Meeting Date:  
June 18, 2026

Location:  
86 Owen Brown St

Request:  
Variance requests for stream  
corridor setback and rear  
yard setback

The subject of this hearing is a request for three variances to allow for the construction related to a townhome development that includes a public multipurpose path extension of Veterans Trail (see site plan on reverse side). The variances are:

Fig. 2

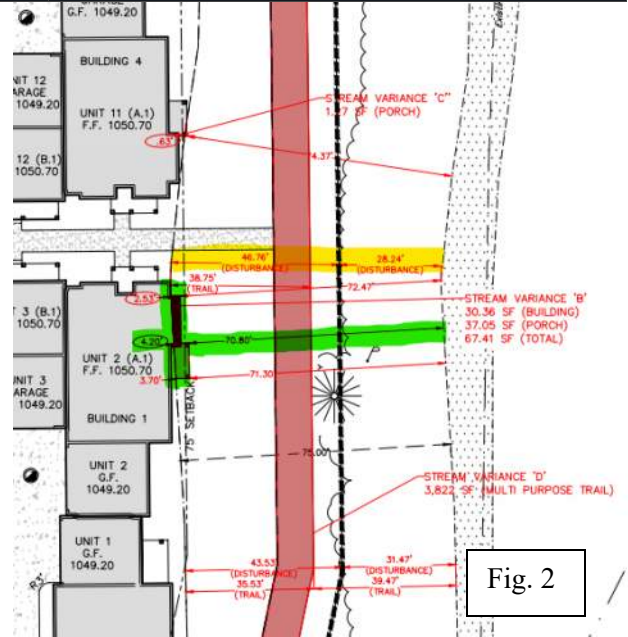
The multi-purpose trail would encroach into the stream corridor setback by approximately forty-seven (47) feet. The proposed townhome development would encroach into the stream corridor setback by approximately five (5) feet.

Figure 2 depicts the proposed townhome development encroachment highlighted in green and the proposed multi-purpose path encroachment highlighted in yellow.

Fig. 3

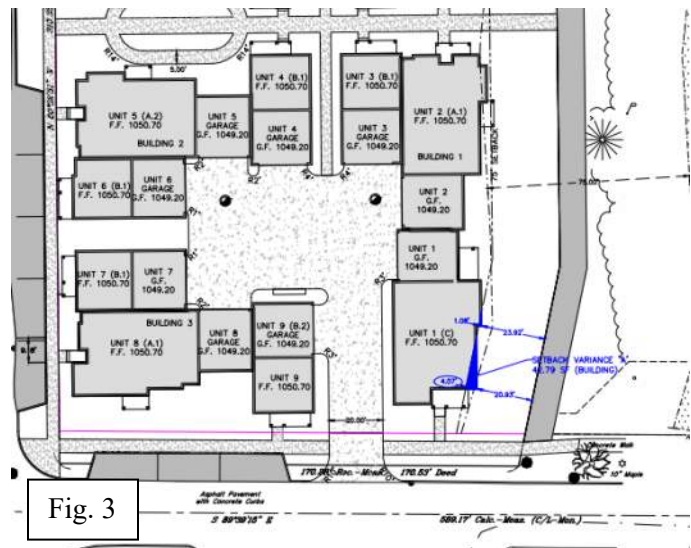
Figure 3 depicts the section of the proposed townhome development that would encroach into the rear yard in blue.

The unit, "Unit 1", with the proposed rear yard setback variance is limited by the rear property line that is angled. Furthermore, the proposed setback would allow for increased interior circulation and additional interior open space.

The variance would represent a 20% deviation from the code requirement. Staff notes that approximately forty-three (43) square feet of Unit 1 encroaches into the rear yard setback.

**C3.01B**

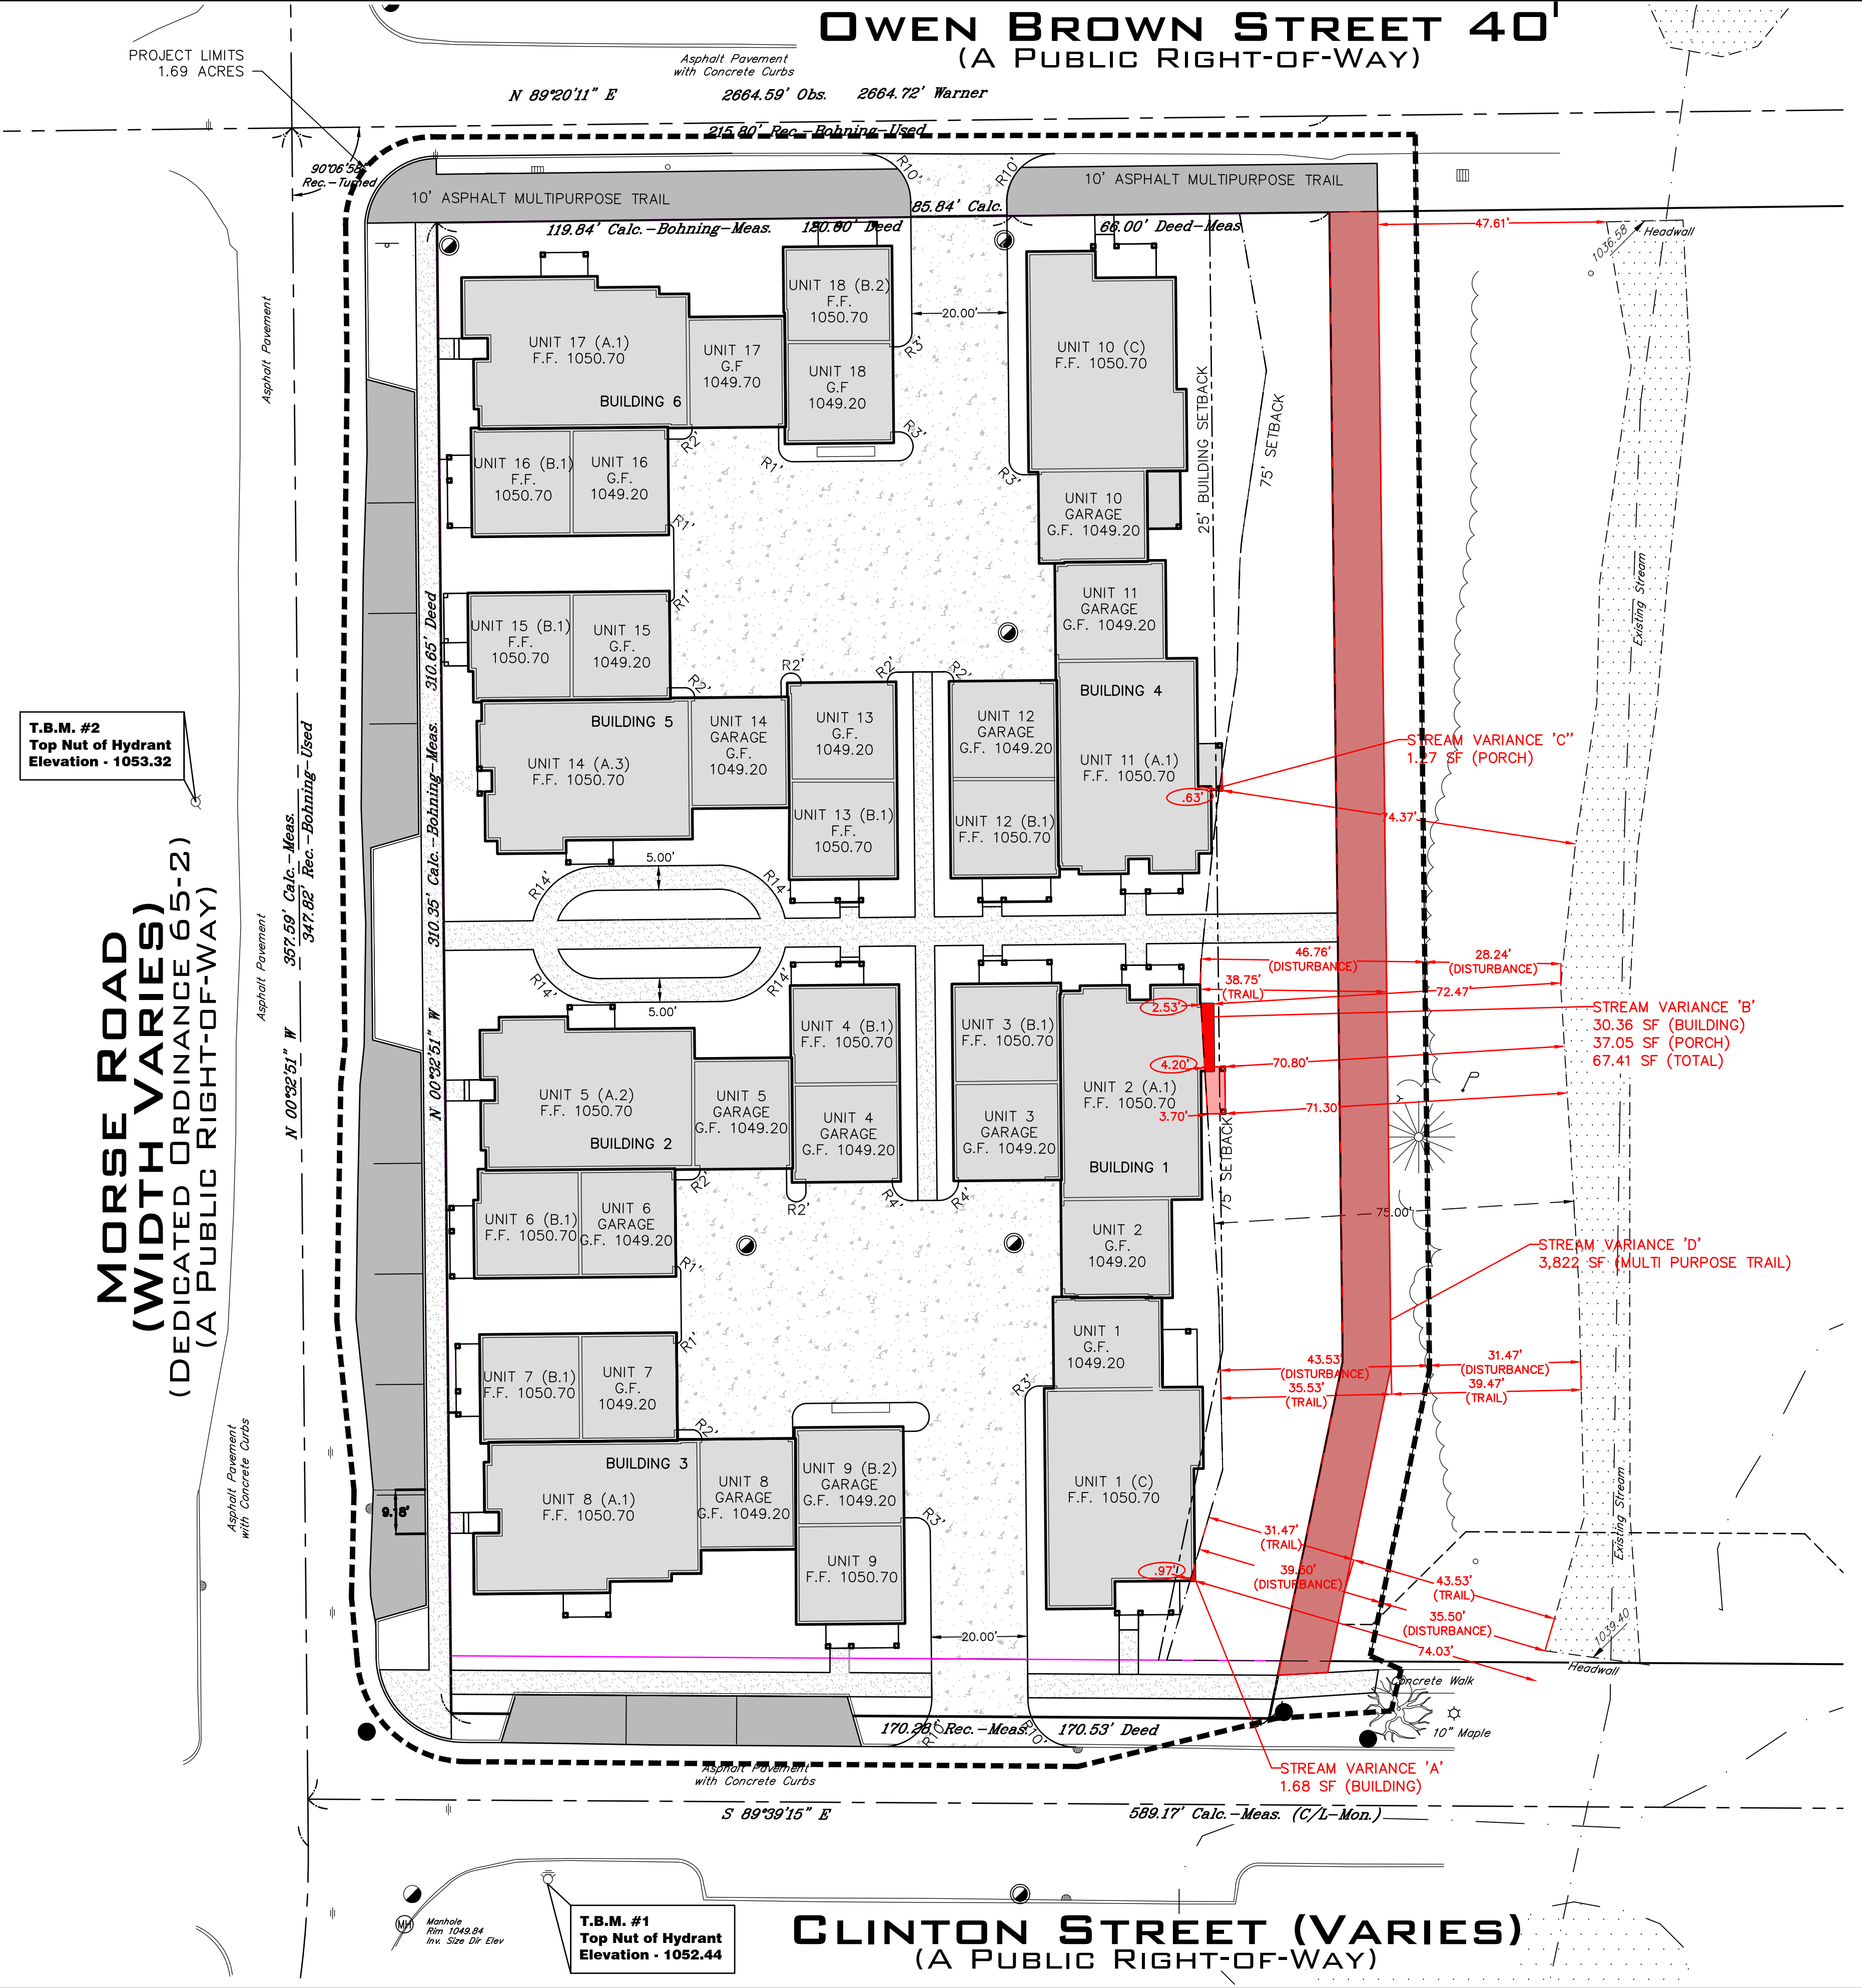
STREAM SETBACK

VARIANCE 'A' UNIT 1  
2.0' BUILDING  
1.68 SF

VARIANCE 'B' UNIT 2  
5.0' PORCH  
3.0' BAY  
67.41 SF

VARIANCE 'C'  
2.0' PORCH  
1.27 SF

6,801 SF TOTAL DISTURBANCE (PROPERTY)

VARIANCE 'D' (CITY PROPERTY)  
39.0' TRAIL  
3,057 SF MULTIPURPOSE TRAIL (IMPERVIOUS AREA)  
5,456 SF DISTURBANCE
